Our File: EA1415-01

CanZinc responded to the first round of information request (IR) on May 9th, 2016. Some of the responses were not input into the online review system table but rather input as an attachment. The IR responses that were attachments to individual IRs have been compiled here into one pdf document to assist parties. The individual IR responses included are:

Figure A08

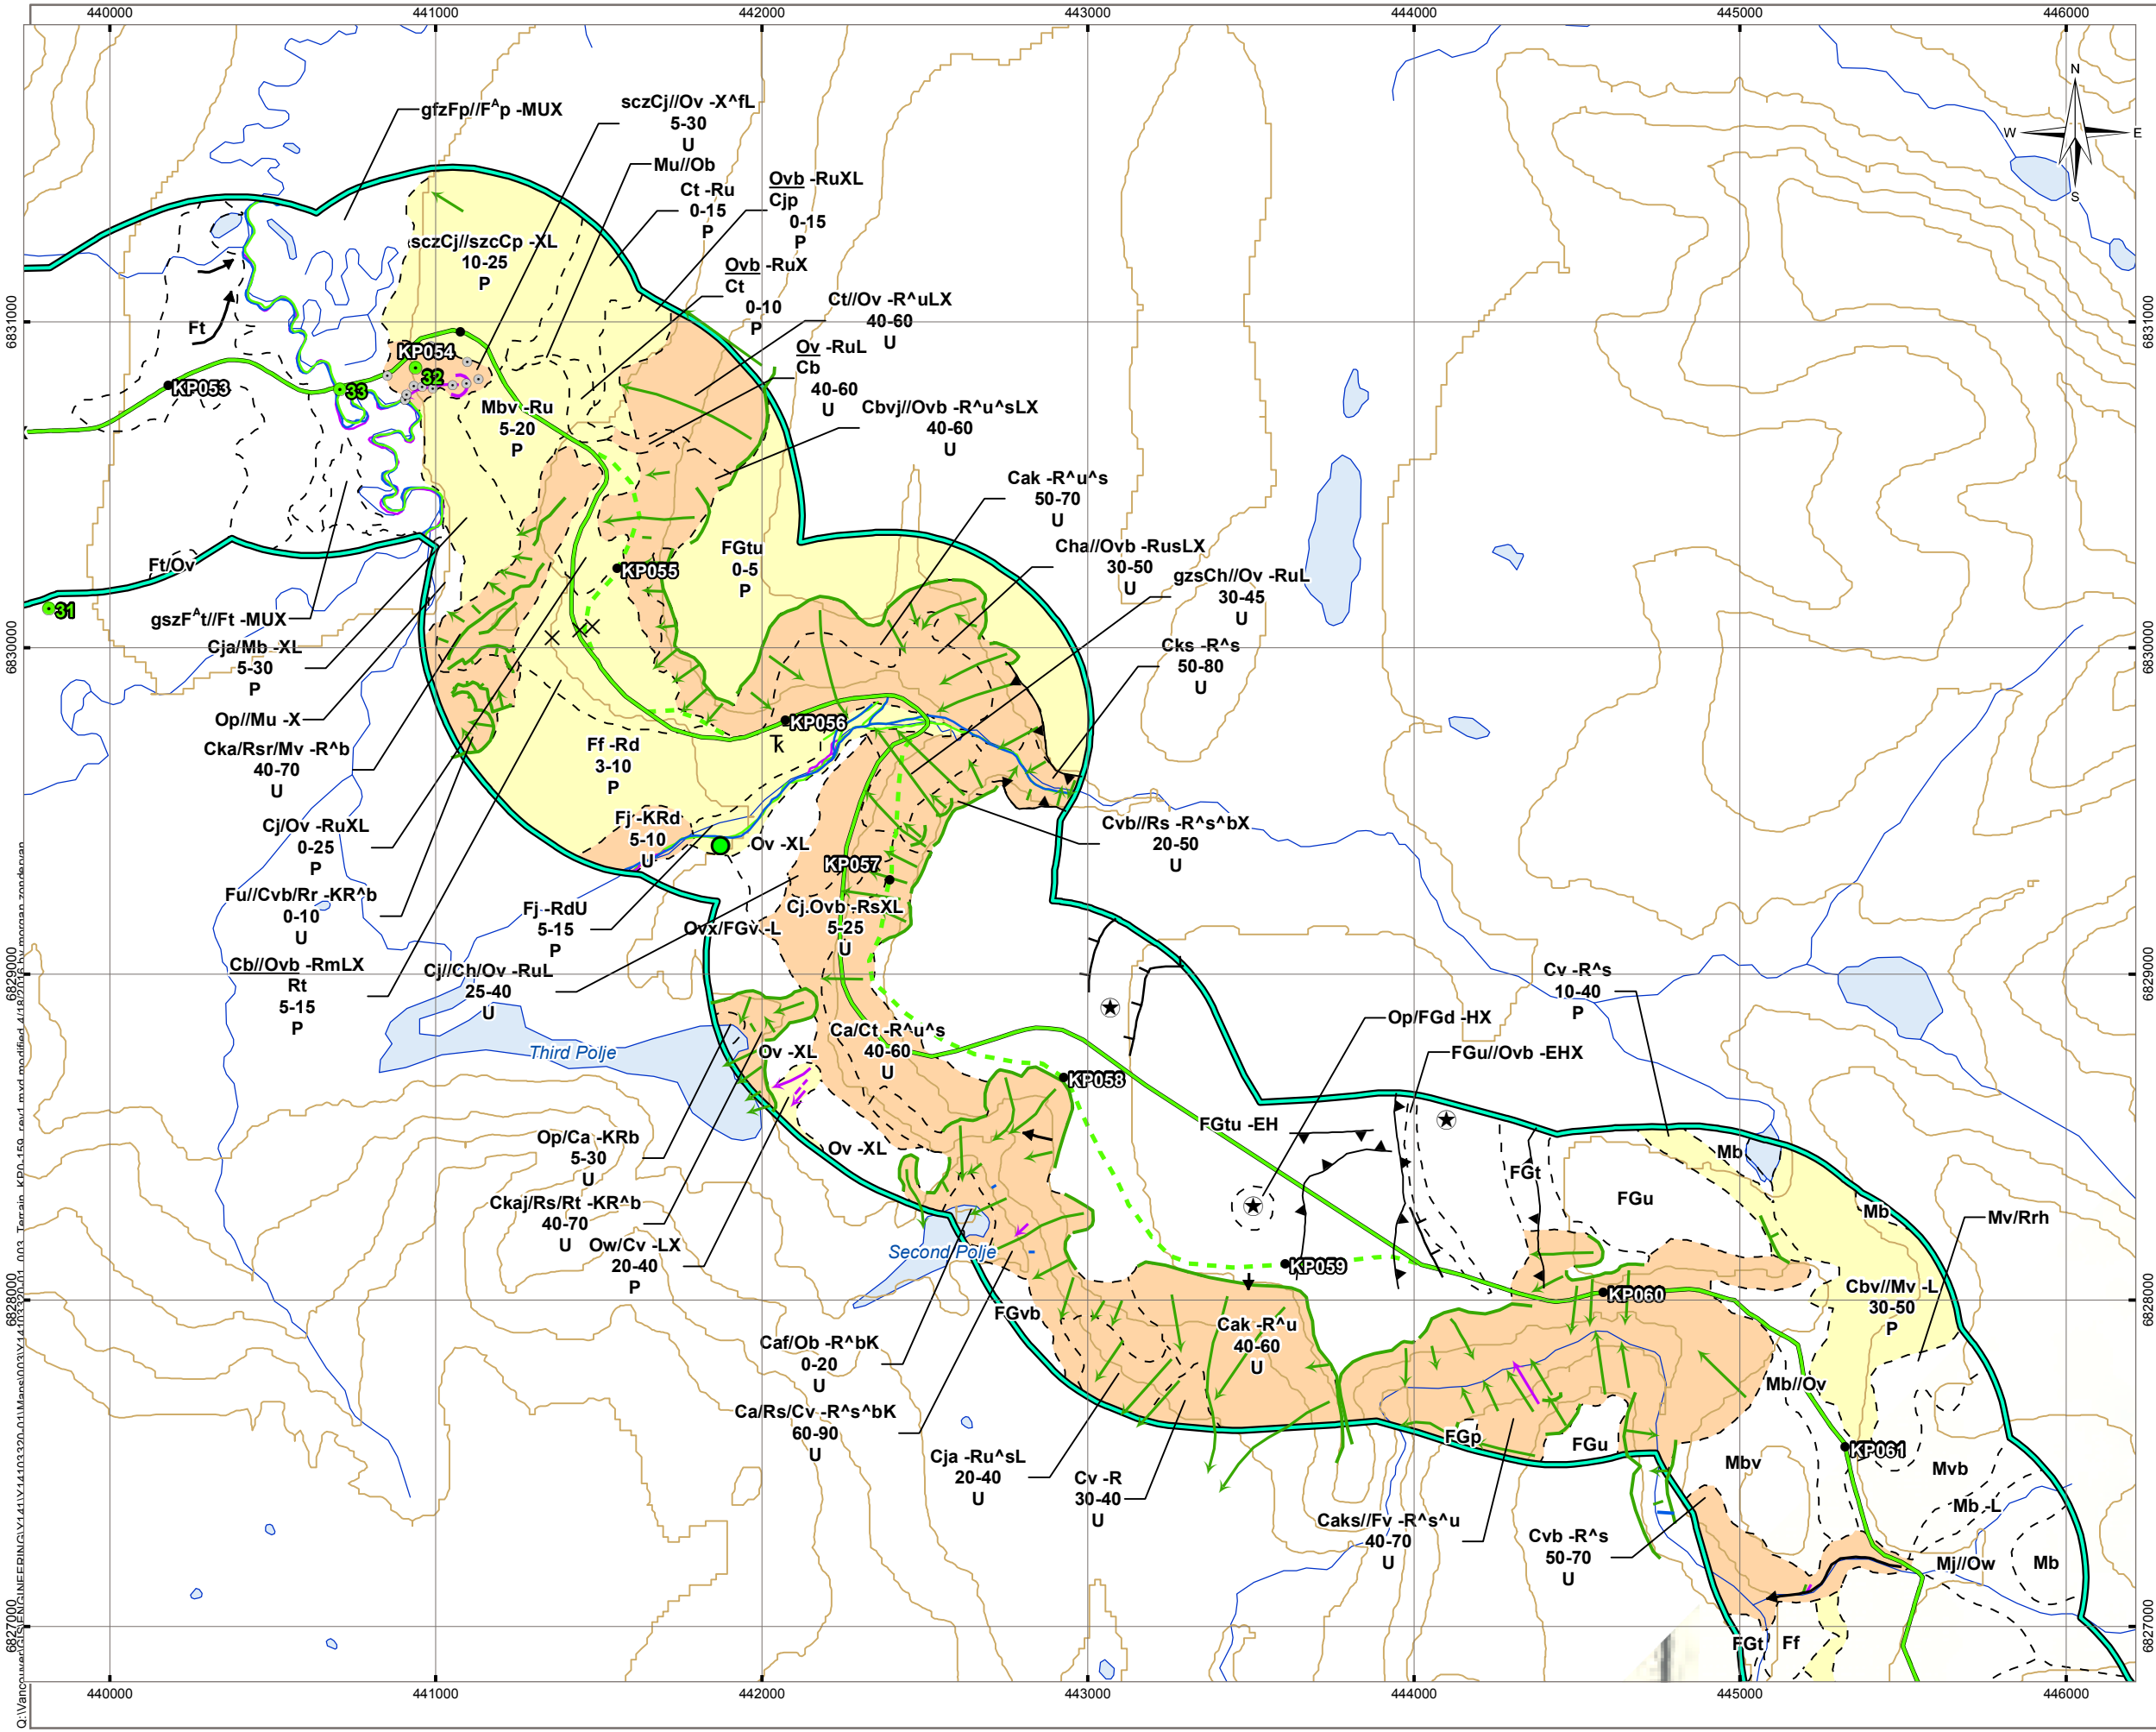
- ii) *“At WP 30 and also on Figure A08: at KP 047.5 Km, there is a thermokarst symbol but the terrain unit letter for thermokarst (t or e) is not used.”* The point symbols at these locations represent small landslide scars. The generic “Landslide and Active Layer Failure Scar (small)” on the legend has been changed to “Landslide (small)” and Figure A08 revised.

Figure A09

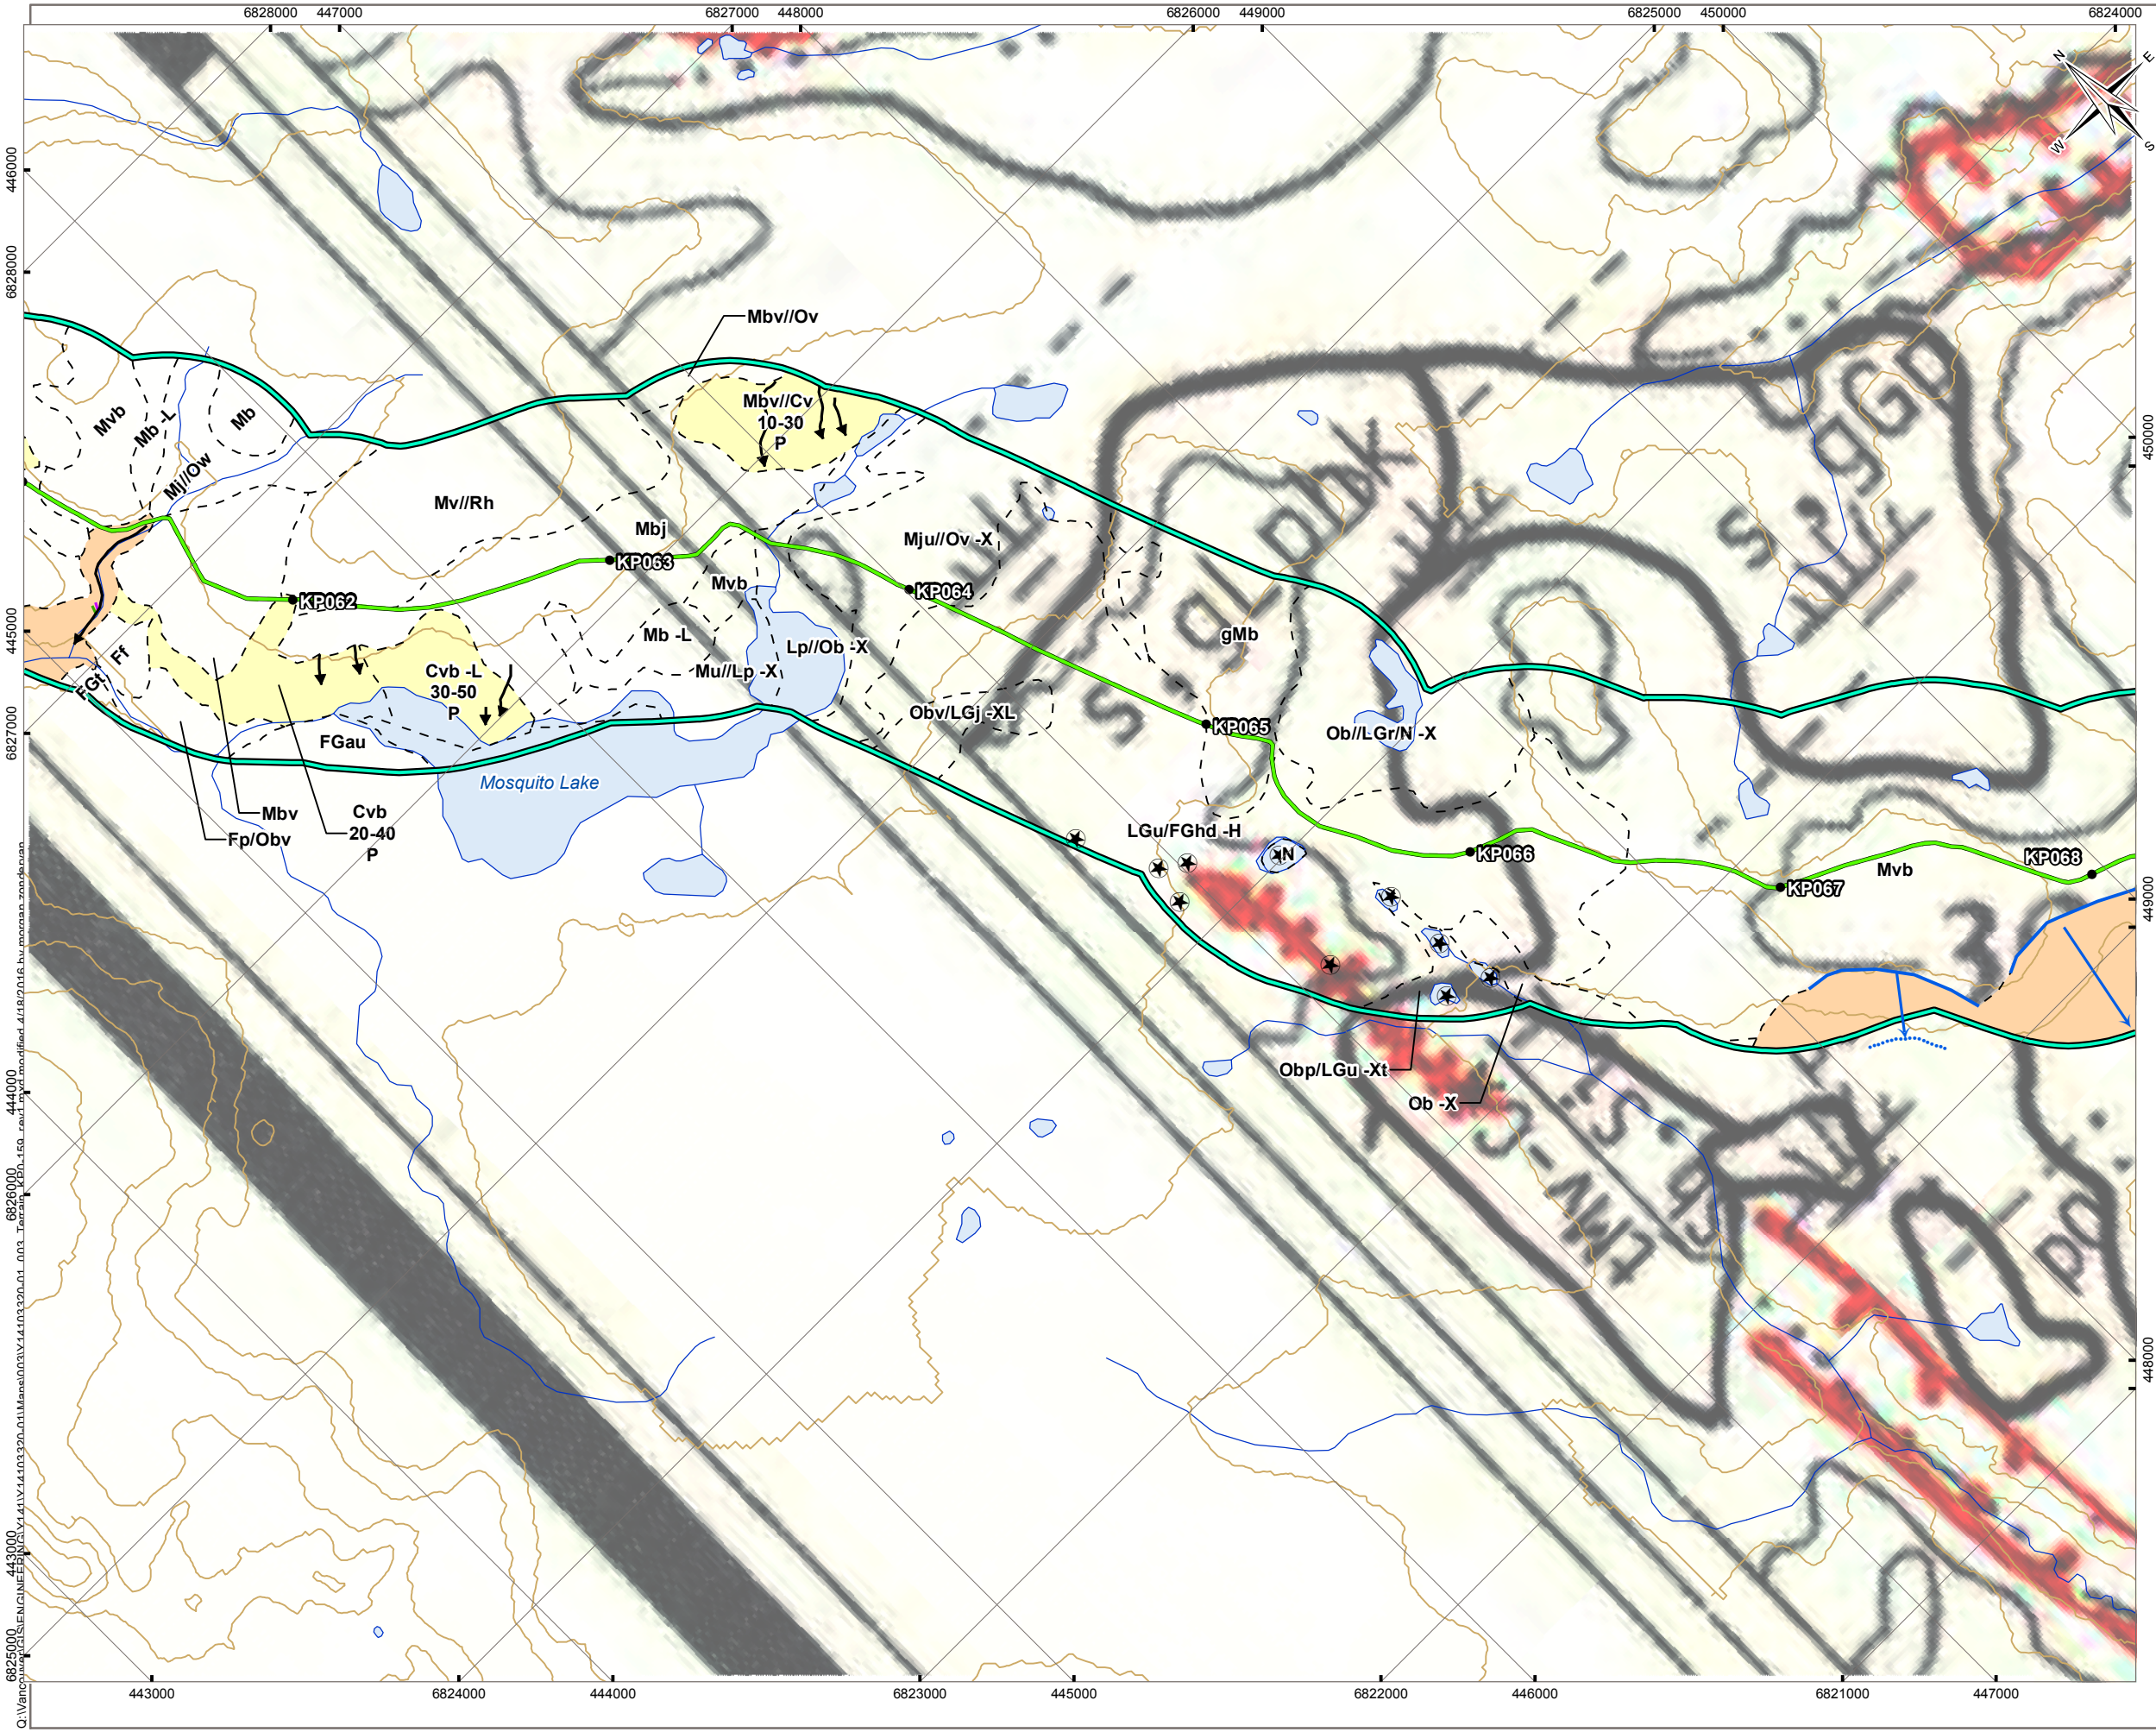
- The kettle symbol that was adjacent to the small pond (indicating the pond might also be a kettle) in the original figures has been removed as it caused some confusion. Revised Figure A09 attached.
